Reference: U.S. Geological Survey TRIGA Reactor (GSTR), Docket 50-274, License R-113, Request for Additional Information (RAI) dated September 10, 2015.

Subject: Responses to RAI questions 1a, 1b, and 1c.

RAI dated 9/10/2015

**Figure 1. Minimum Departure from Nucleate Boiling Ratio as a function of rod power for the six flow channel cases in Table 1, using conservative Bernath correlations.**

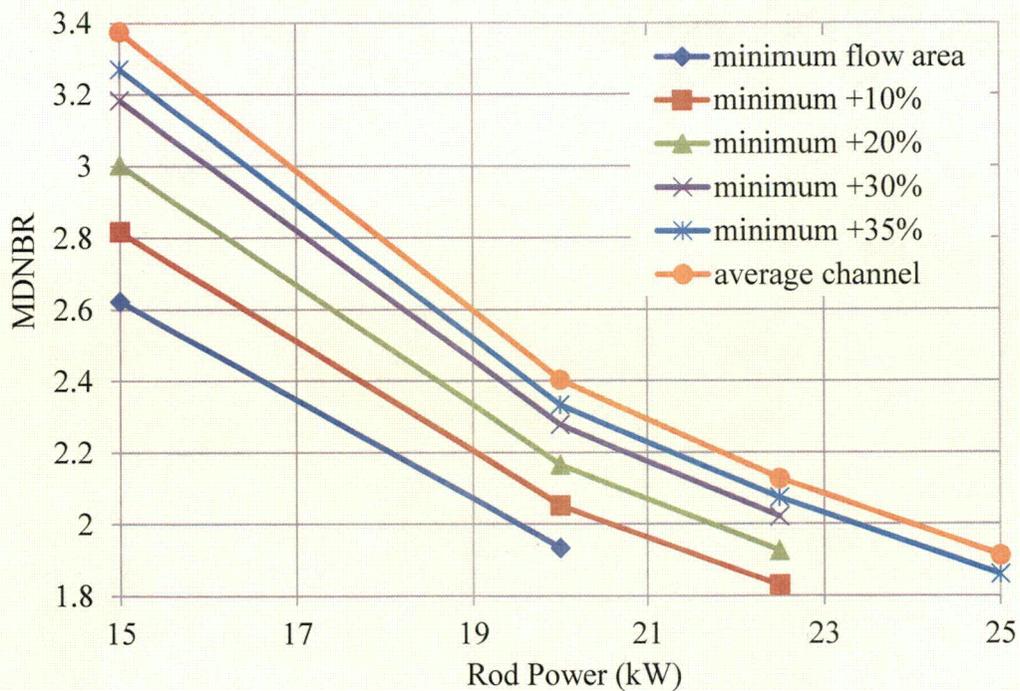
- b. The parameters chosen that defined the flow area of the limiting hot channel do not appear to be consistent for performing the limiting sub-channel analysis. The flow area appears to be approximately 20 percent larger than the limiting channel flow area, as determined by the NRC staff in their confirmatory analysis, due to non-conservative assumptions in the selection of the hydraulic channel orientation relative to the limiting fuel elements. Determine a limiting hot channel flow area conservative for the LCC T-HA.

Figure 1 displays the MDNBR predicted by the conservative Bernath correlation as a function of rod power, based on data provided by the Colorado School of Mines RELAP5/Mod 3.3 model of the GSTR flow channel for each case in Table 1. The far right data point for each line corresponds to the last calculation without flow instabilities. Thus, every point on this graph represents stable flow predicted by the RELAP model. Figure 2 shows the mass flow rates as a function of rod power predicted by the RELAP5 model for each case in Table 1. An examination of Figures 1 and 2 show that the 35% greater flow area and the average channel cases predict stable flow at rod powers in excess of 25 kW with a MDNBR in excess of 2 at a rod power of 22.5 kW. Even a very modest increase of 10% in the flow area results in stable flow at a rod power of 22.5 kW with a MDNBR in excess of 1.8. In conclusion, the LCC has sufficient cooling even with a very conservative thermal-hydraulics analysis.

**Figure 5. Minimum Departure from Nucleate Boiling Ratio as a function of coolant inlet temperature for the “minimum” case in Table 1 at a rod power of 20 kW.**

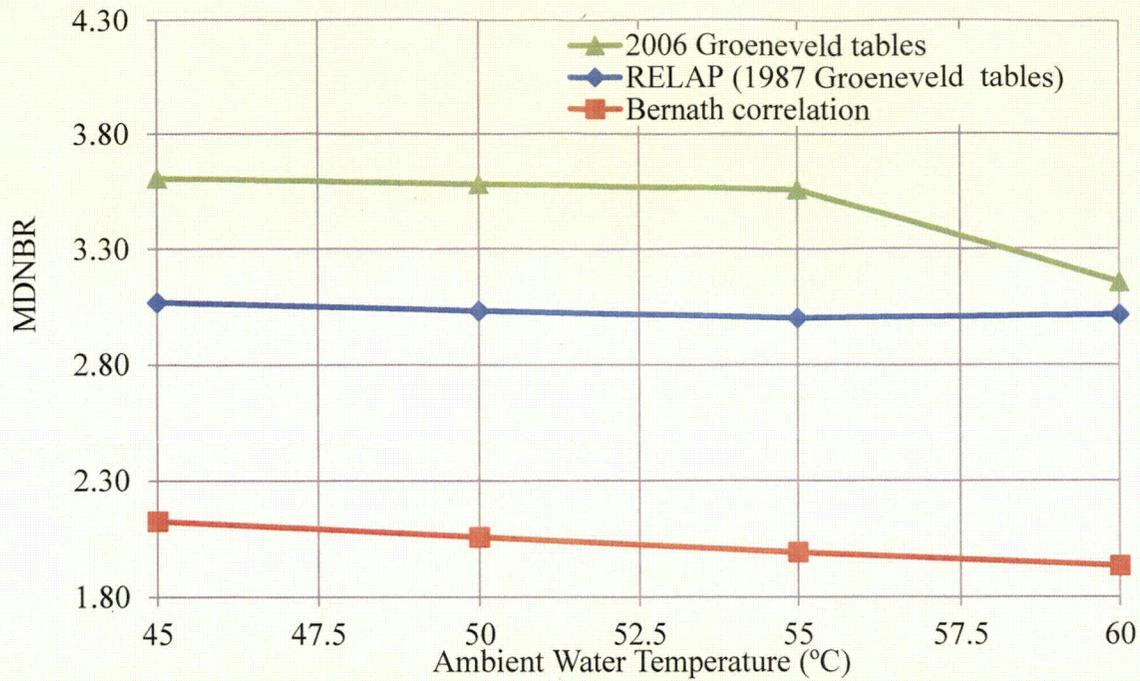
- c. If any assumptions were used in the updated LCC T-HA with regard to any difference between the temperature of the bulk pool water versus the temperature of the core inlet (at the lower core support (grid) plate entrance to the fuel array), provide supporting validation information to substantiate any assumptions used, as necessary.

The calculations presented in 1.b., above, are all based on a core inlet temperature of  $60^{\circ}\text{C}$ , based on the maximum allowed coolant temperature at the top of the pool. Experiments at the GSTR reveal that the core inlet temperature may be  $>7^{\circ}$  cooler than the upper pool temperature. Figure 5 displays the MDNBR at 20 kW per rod for the minimum channel case as a function of core inlet temperature. Figure 6 shows the empirical data for the delta T experiment. Reducing the inlet temperature by  $7^{\circ}\text{C}$  provides a small ( $\sim 5\%$ ) increase in the MDNBR based on the Bernath correlation. The larger increase ( $\sim 12.7$ ) in the MDNBR predicted by the 2006 Groenveld tables between  $60^{\circ}\text{C}$  and  $55^{\circ}\text{C}$  results from a boundary in the look-up table data regions.
